JWA MARK-UP
14 OCT 2011
STUDIO STRATEGY

Client: University of Melbourne
Parkville Campus

Project: Faculty of Architecture
Building and Planning

Title: GENERAL ARRANGEMENT
LEVEL 01 FLOOR PLAN - LO

ACTIVE STUDIO - GROUPS

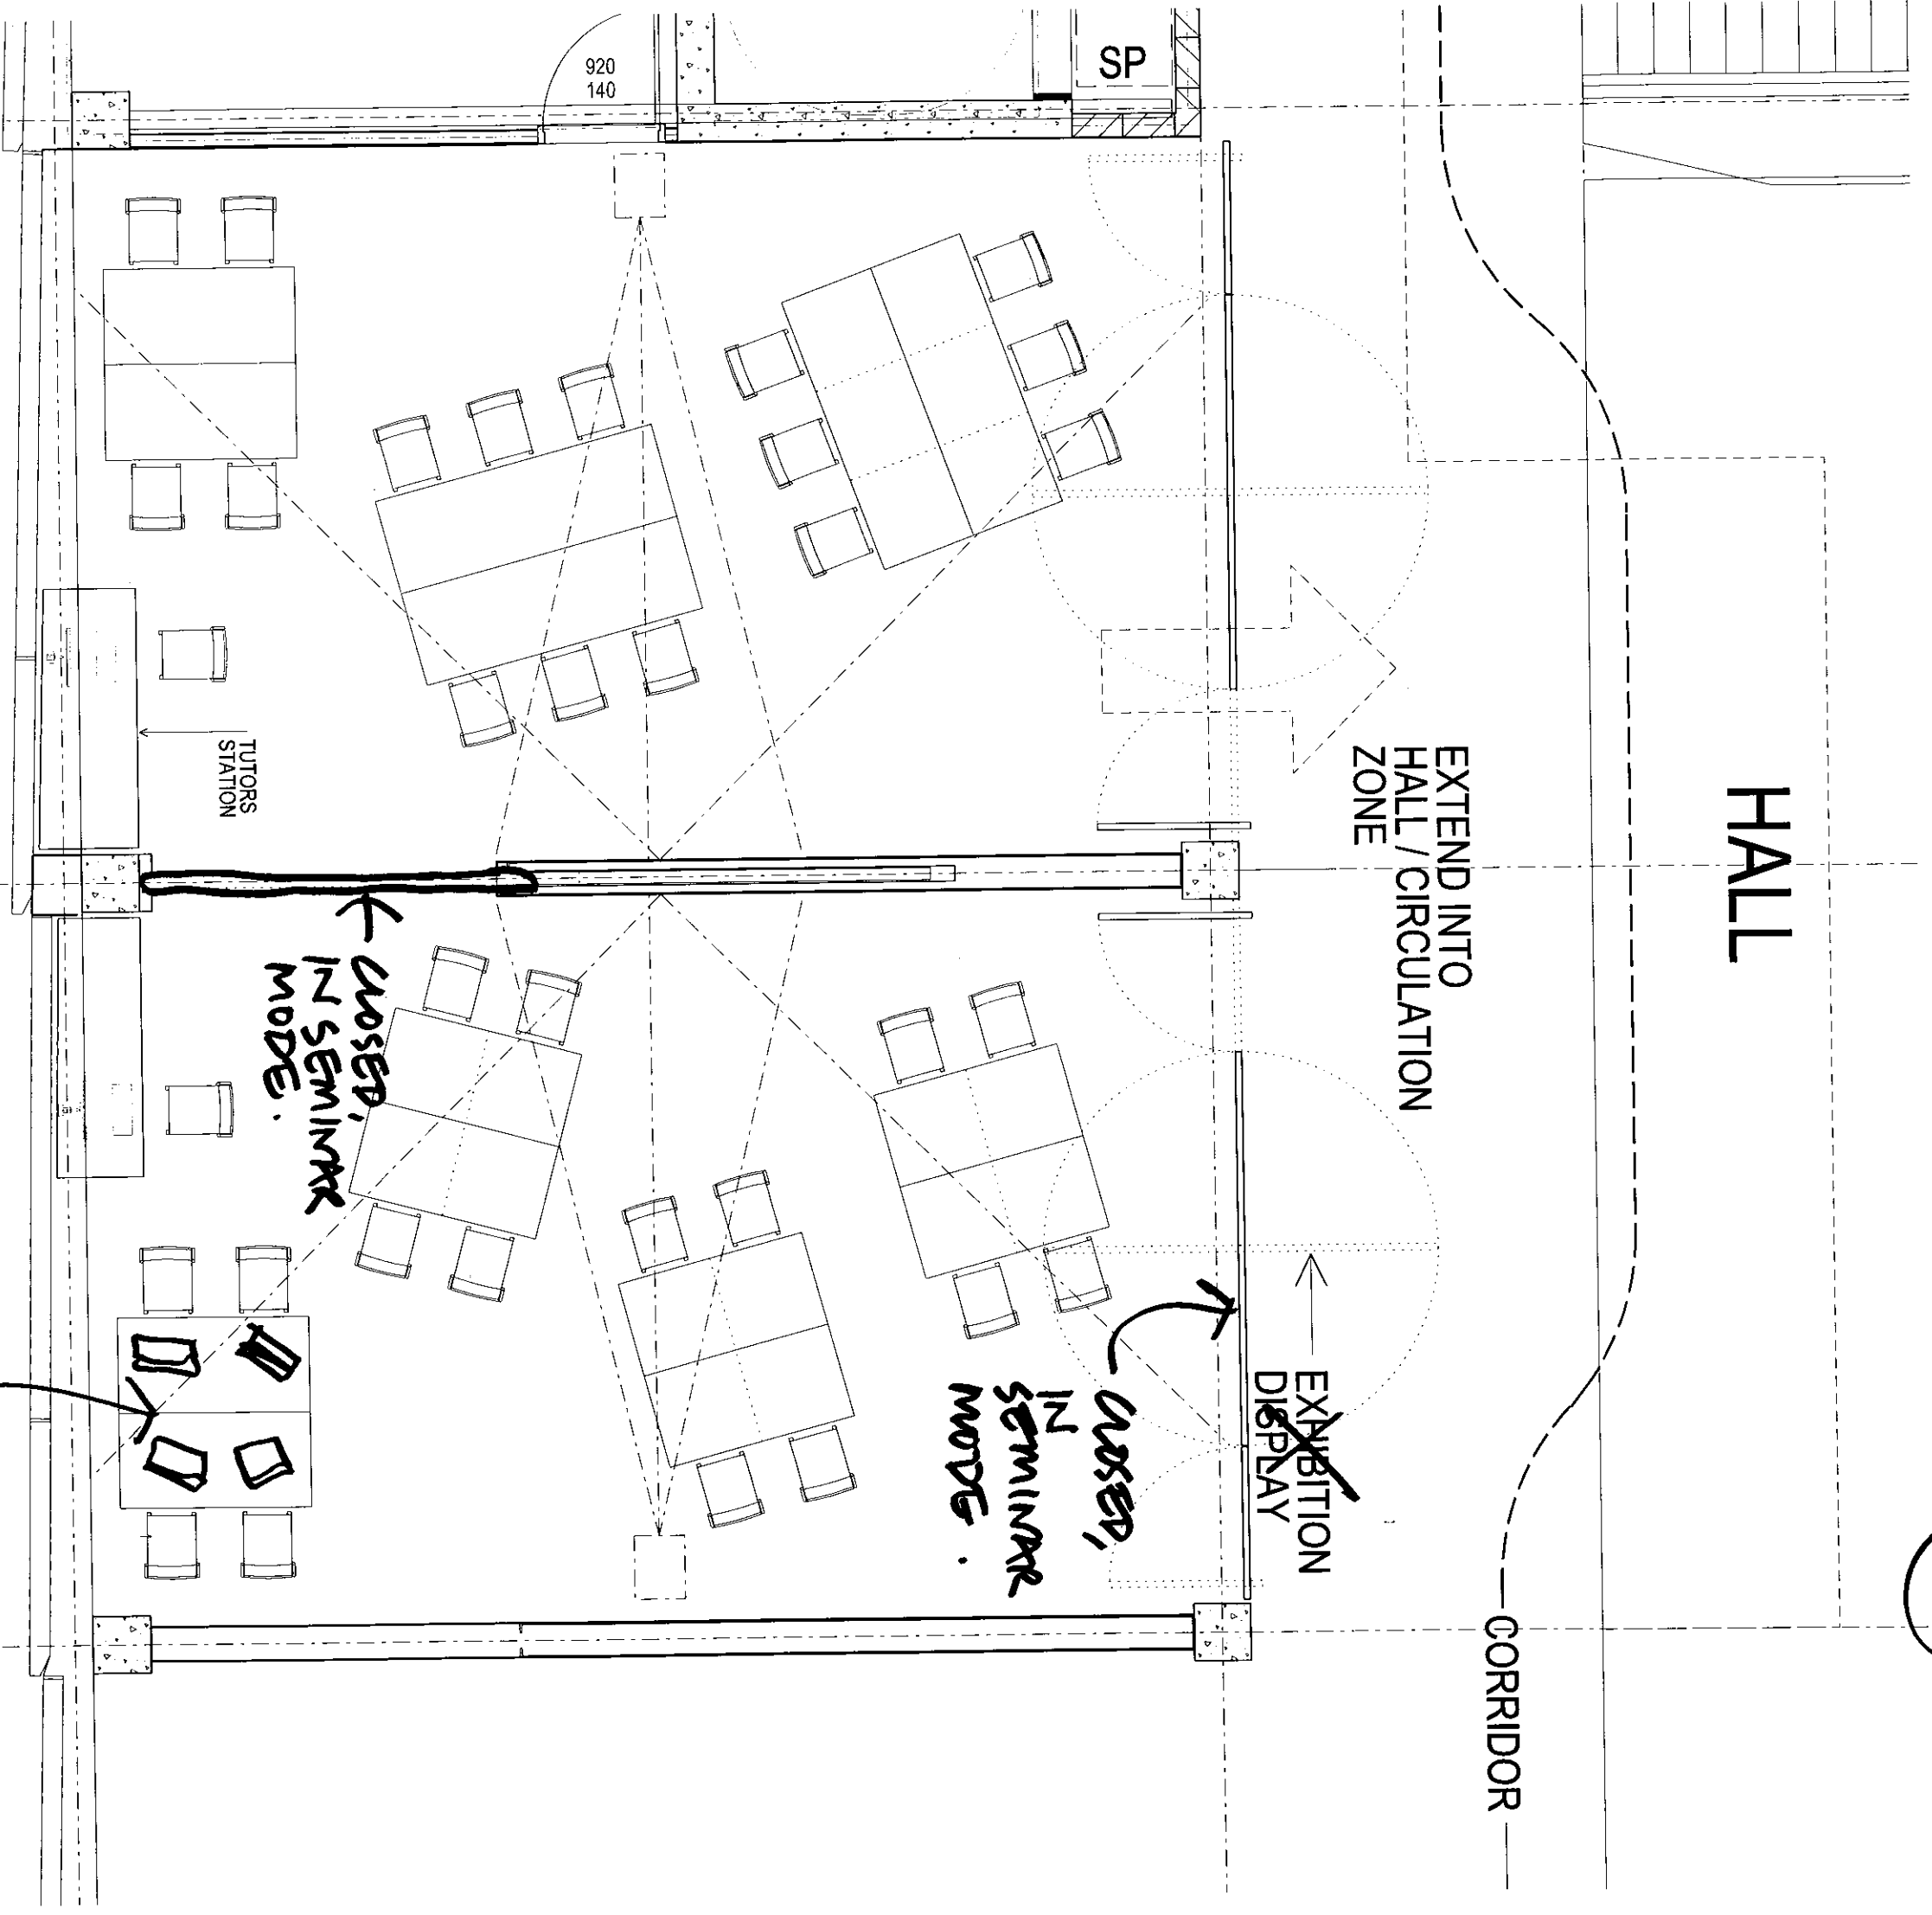
TRUBES TO
BE 900 HIGH.

GROUPWORK
ON 750 DEEP
TRUBES.

ACTIVE STUDIO - LAPTOP GROUPS
WITH SPACE
FOR LAPTOPS.

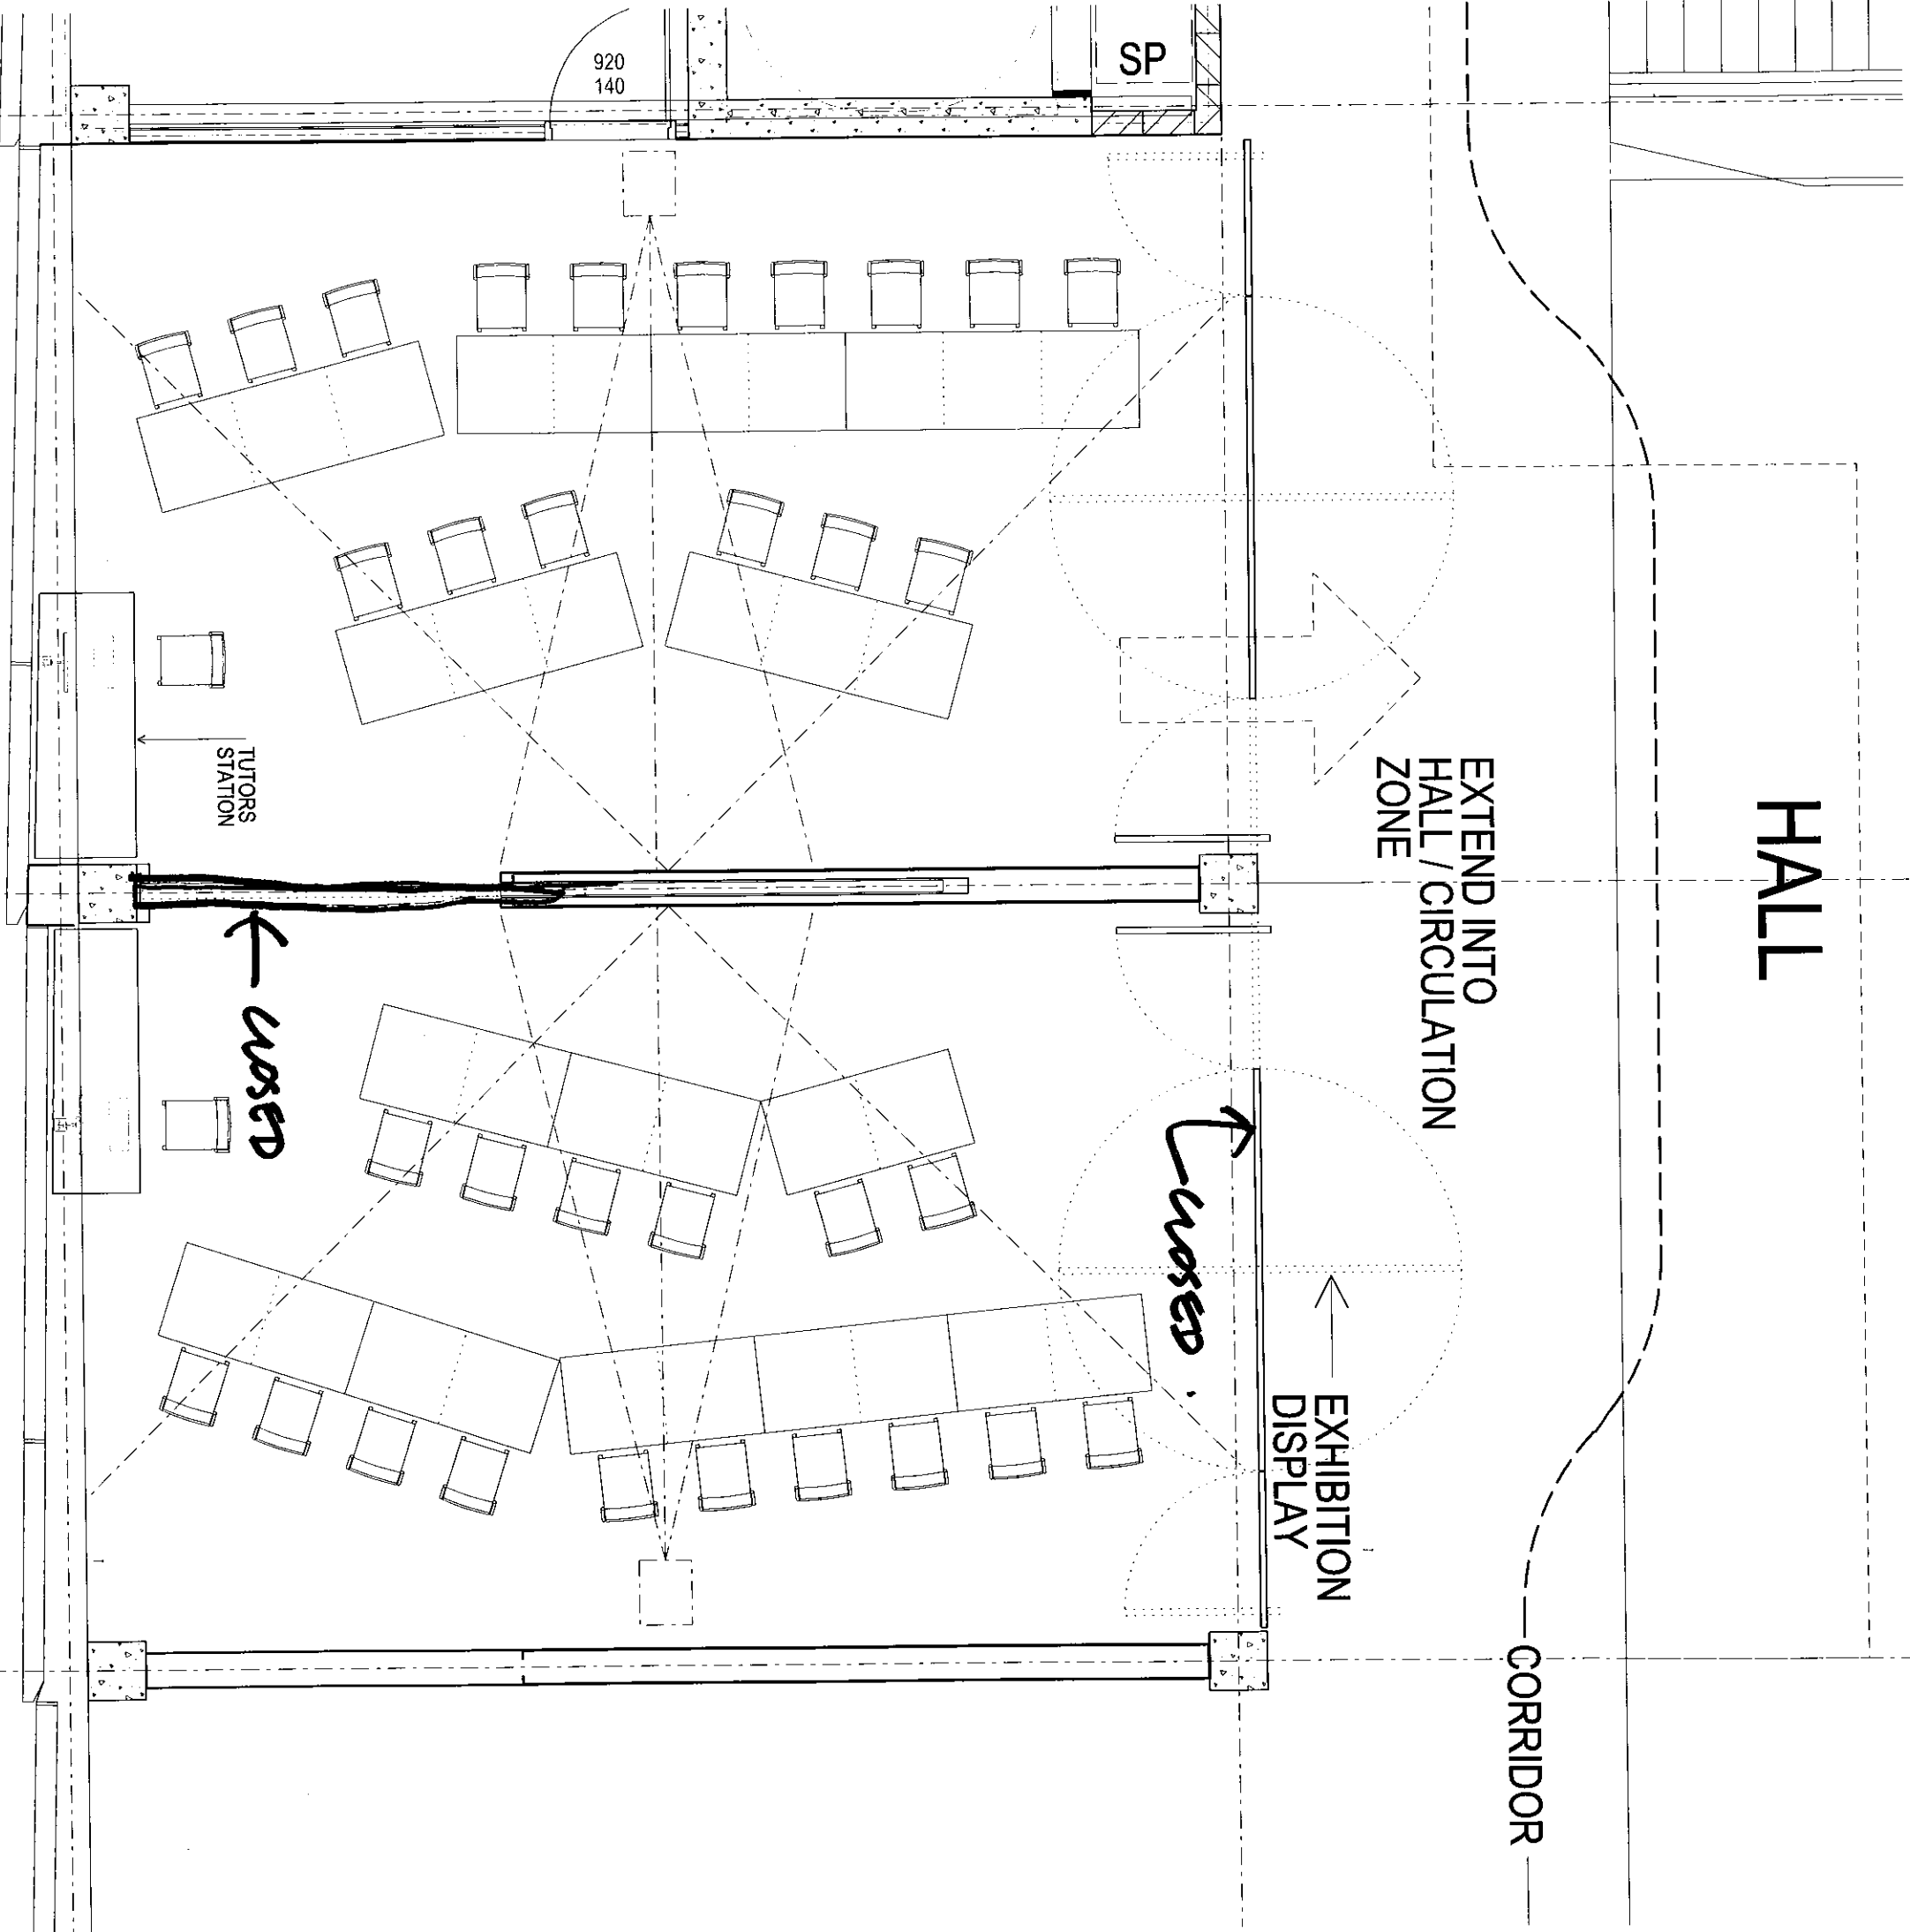
CLOSED,
IN SEMINAR
MODE.

CLOSED,
IN SEMINAR
MODE.

COMPUTER LAB

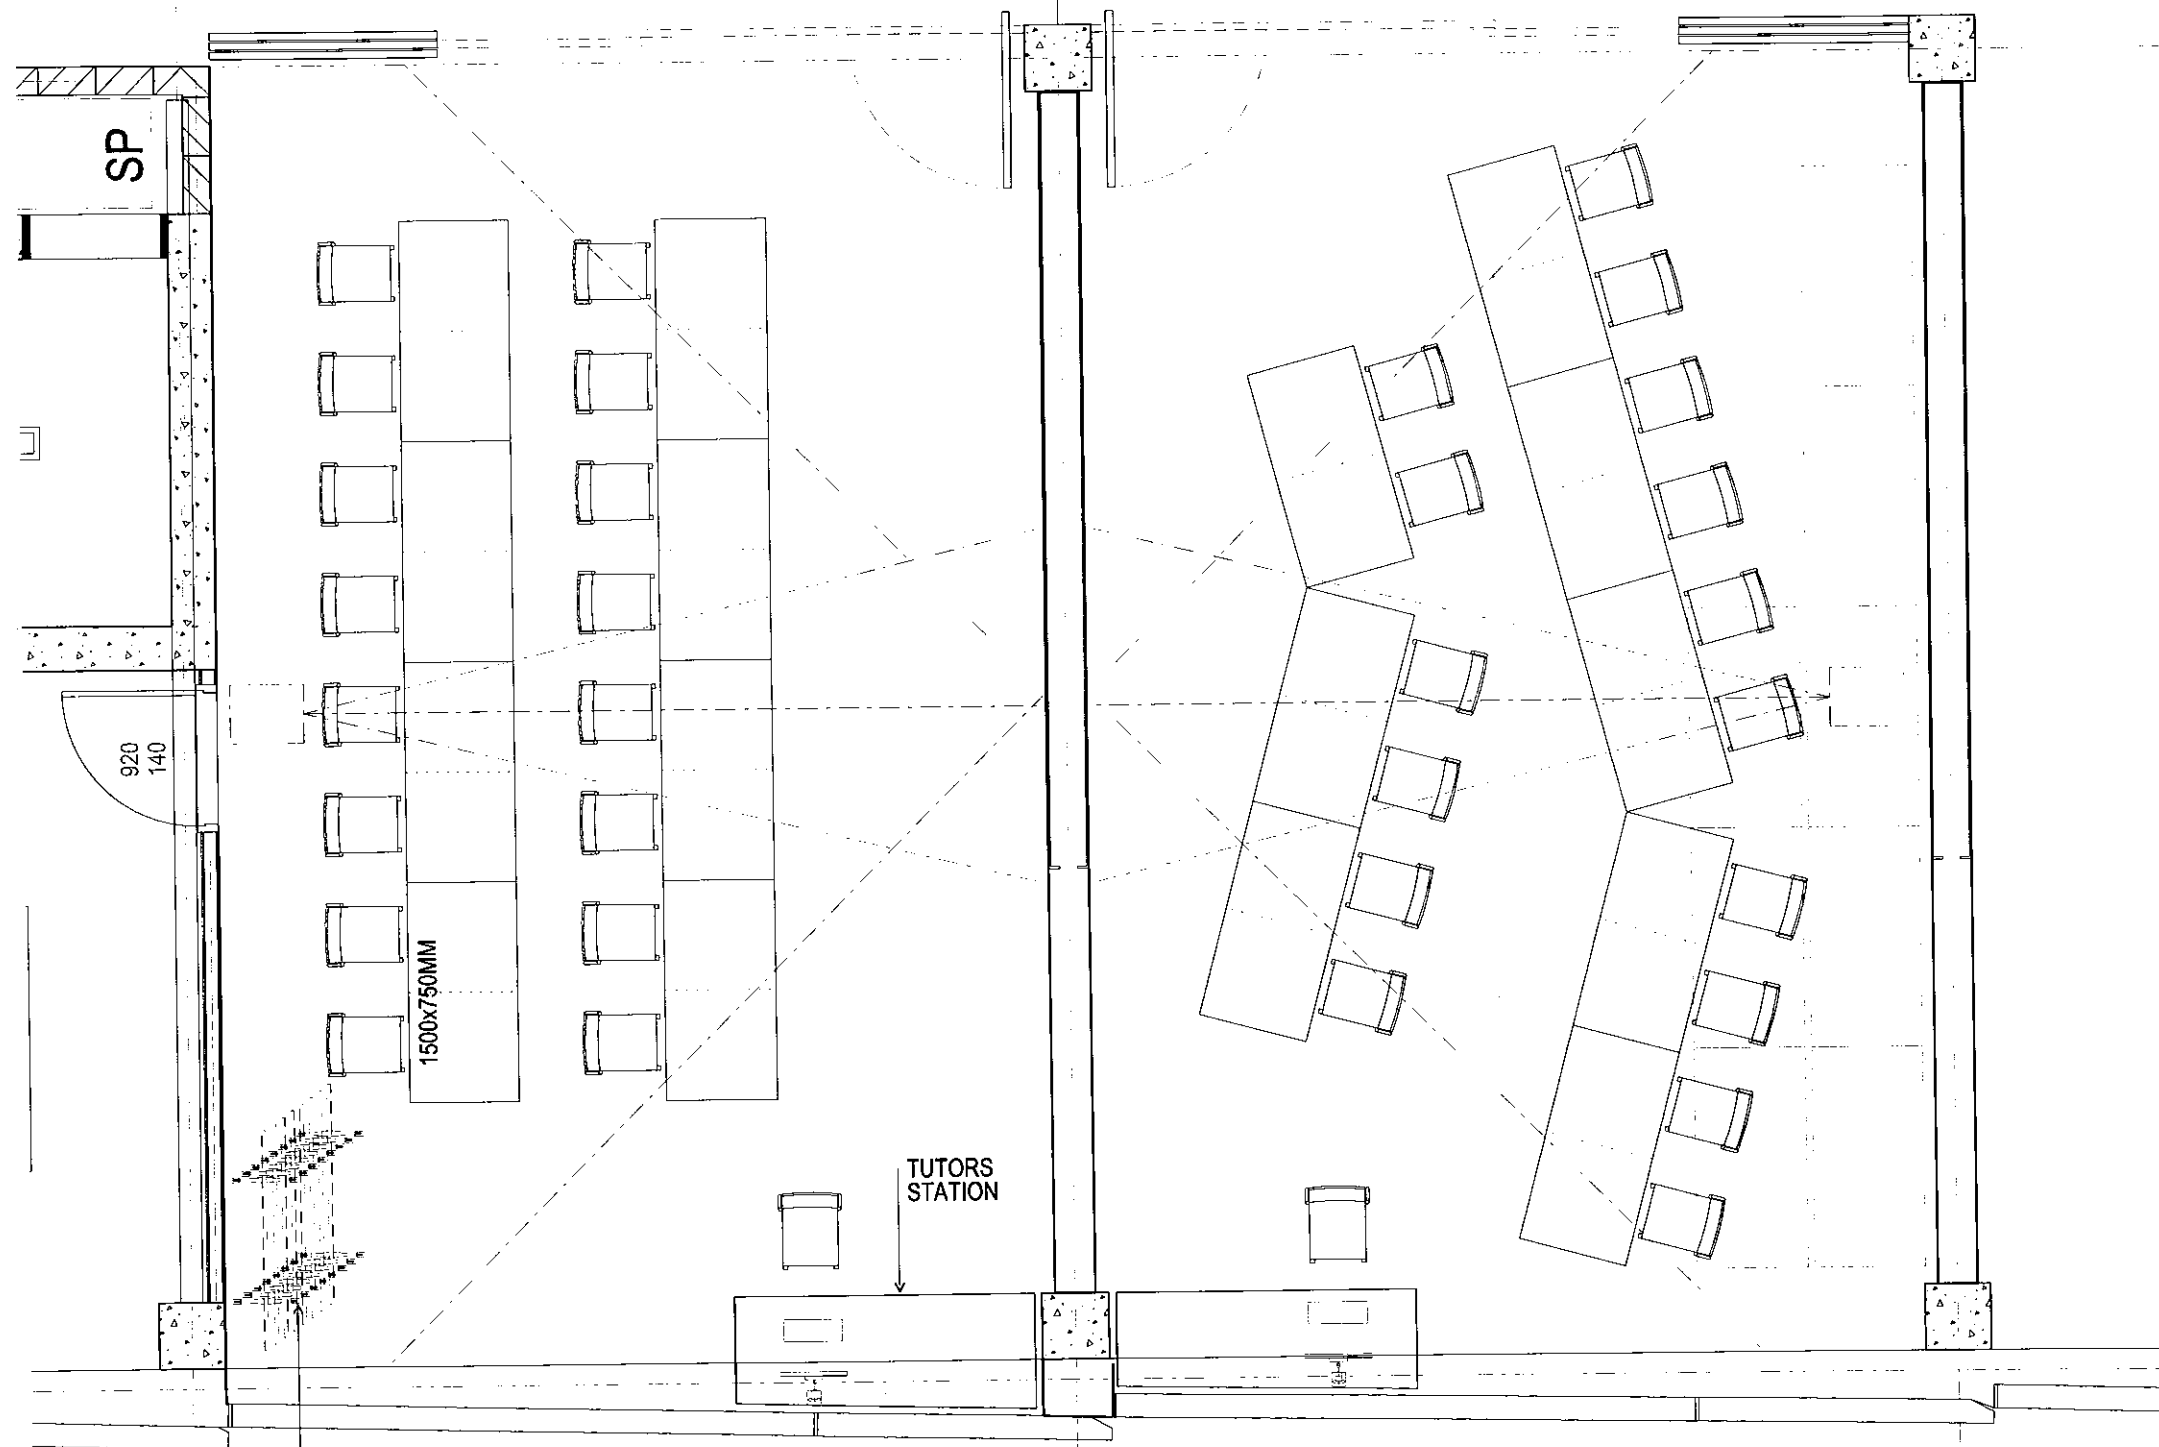
LINKAGE TO
CARD CASE
EXTENDING
TO
HALL
CIRCULATION
ZONE

OPEN UP WITH
SUBING PANEL
ABOVE DESK
HEIGHT.
FIXED INFRASTRUCTURE
REMAINS IN PLACE.
